RESIDENTIAL ENGINEERING SERVICES, LLC.  
SHOP DRAWINGS/SUBMITTAL REVIEW

JOB No.	2534894	JOB No.	2534894
DESCRIPTION	Summit - 63 Manor at Stoney Creek	DESCRIPTION	Summit - 63 Manor at Stoney Creek
JOB ADDRESS		JOB ADDRESS	
CITY	Lee's Summit, MO	CITY	Lee's Summit, MO
DESIGNER	Scott Cleverger	DESIGNER	Scott Cleverger
DATE	11/11/2020	DATE	11/11/2020

ROOF  
TRUSS LAYOUT

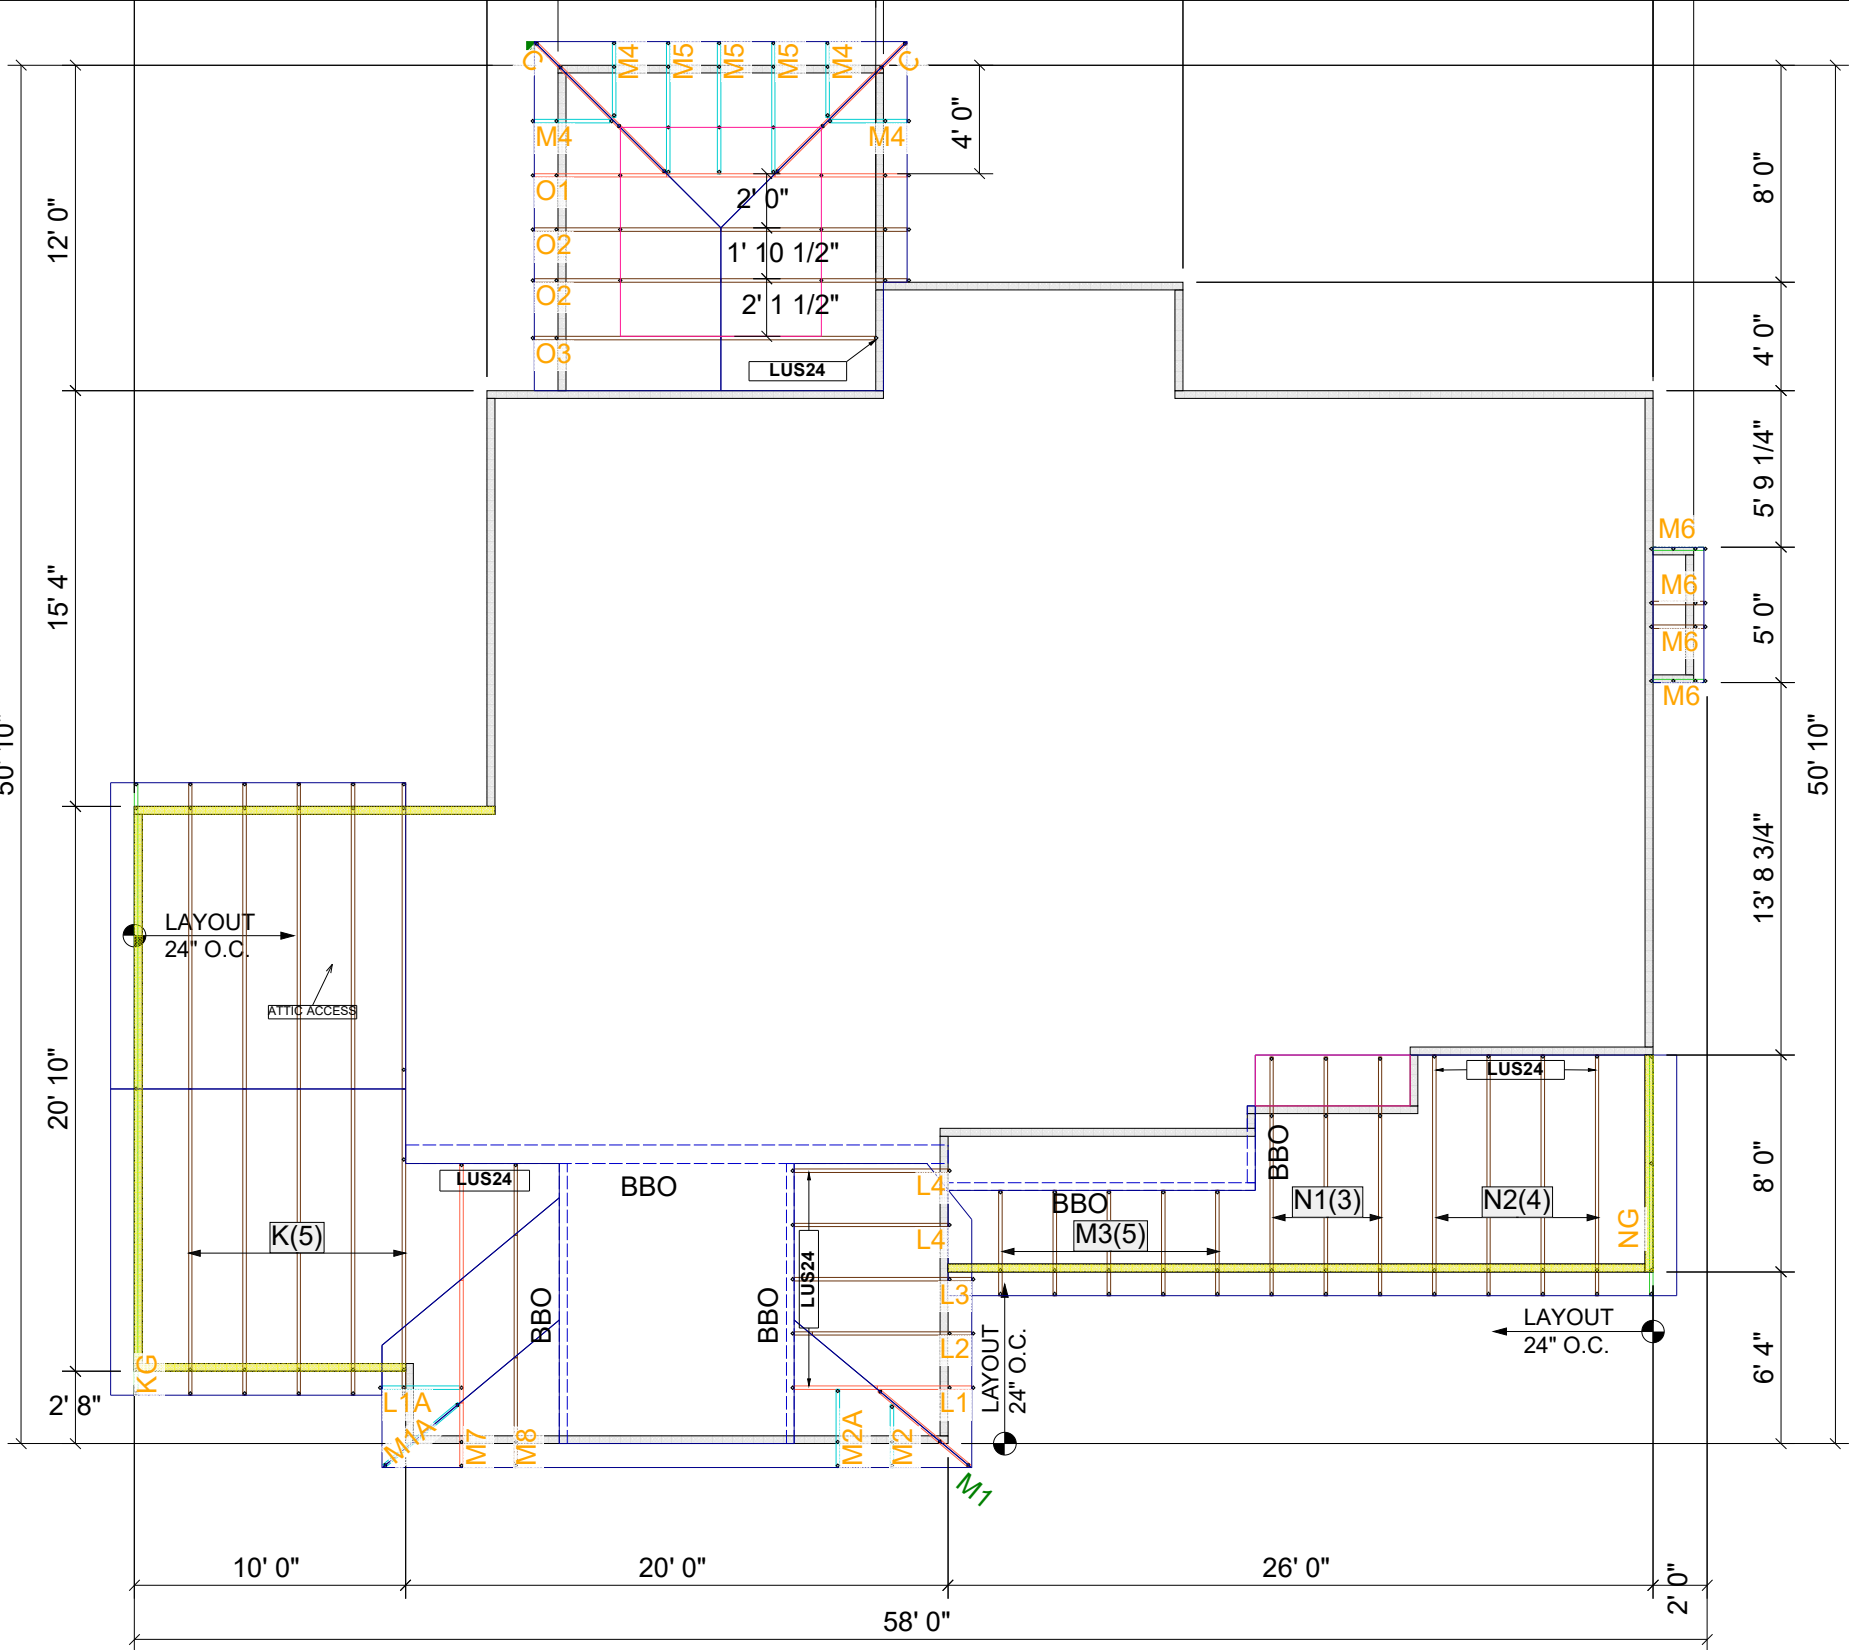
STATUS:

APPROVED

ROOF  
TRUSS LAYOUT

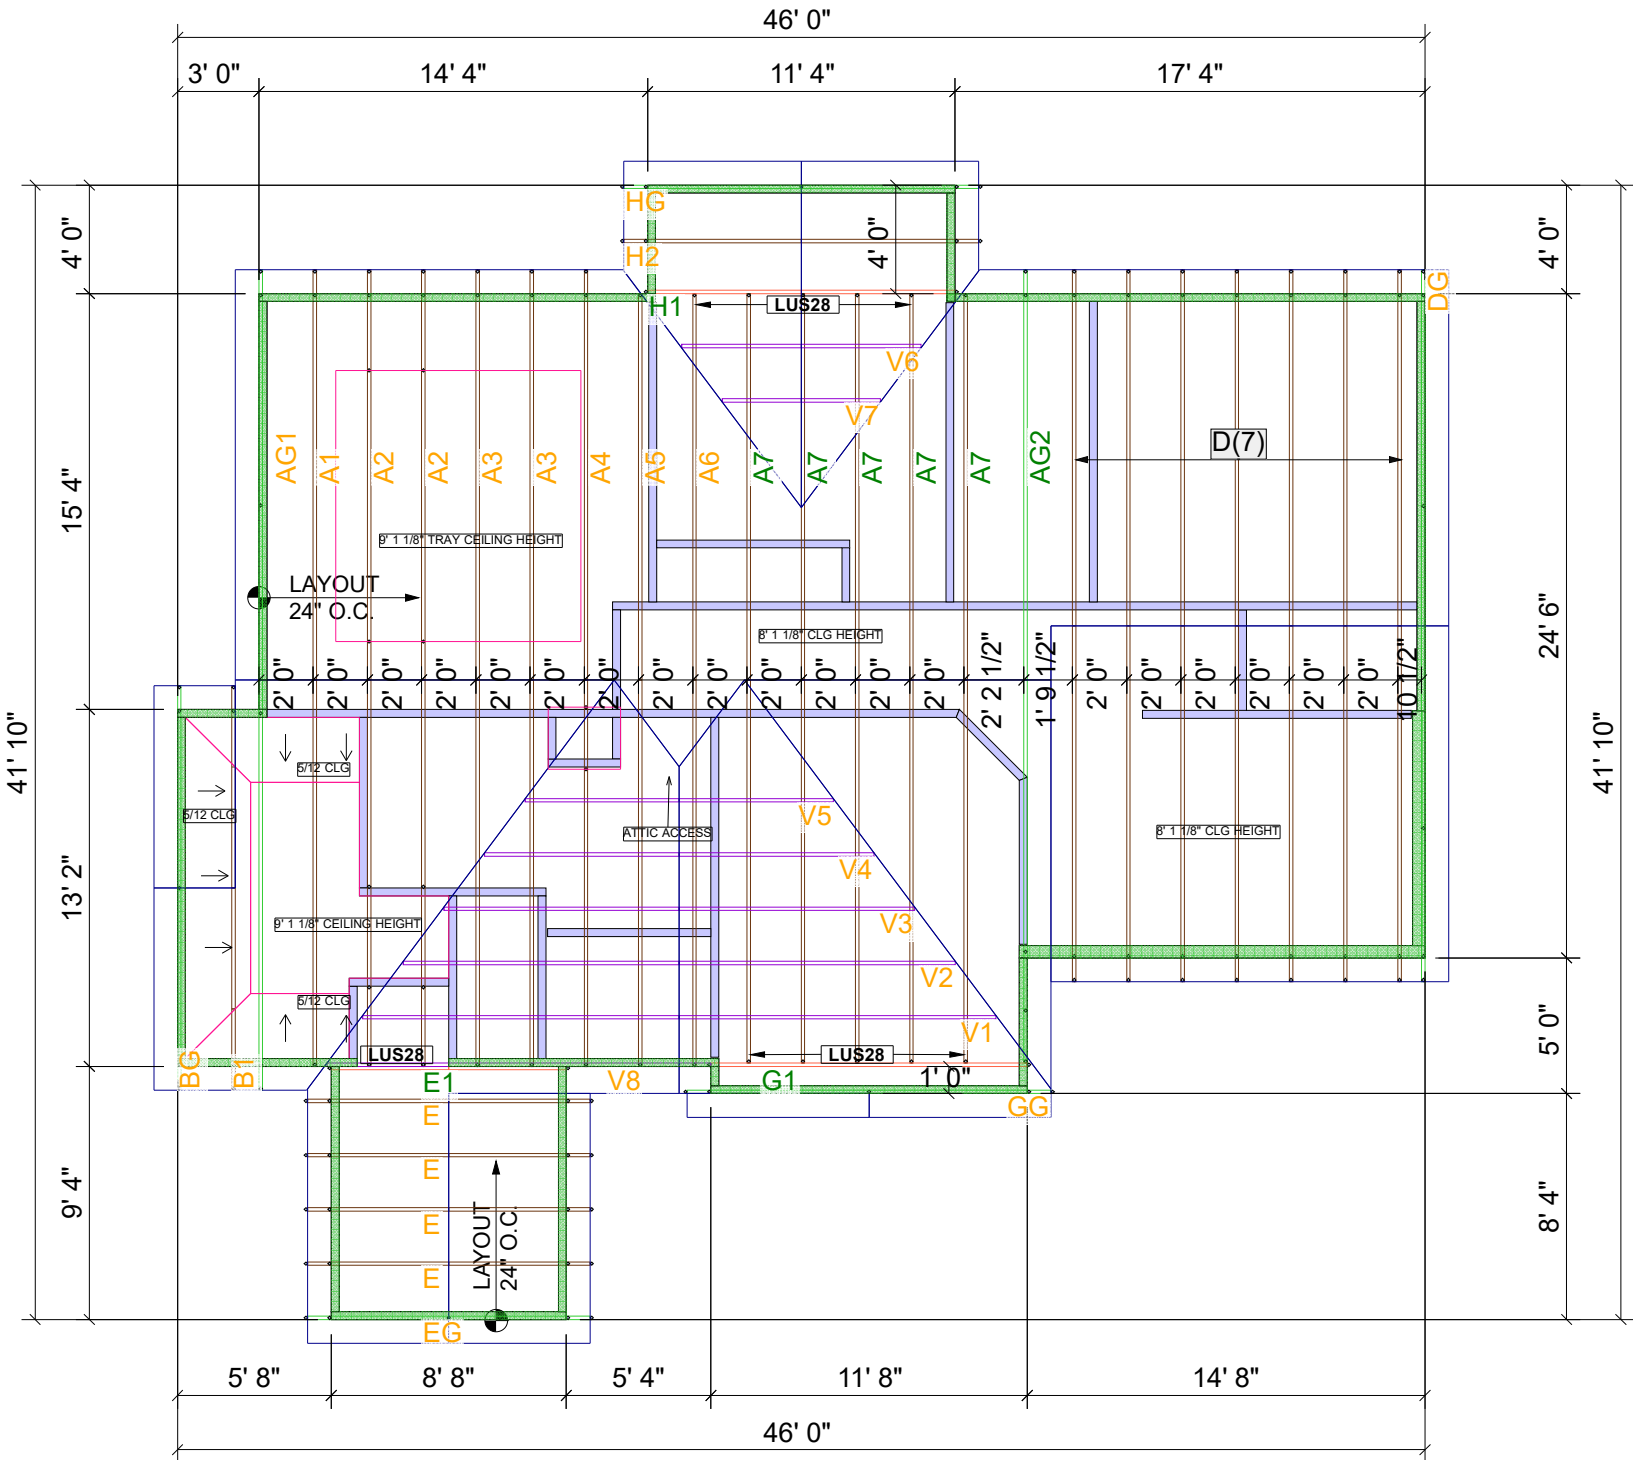
STATUS:

APPROVED
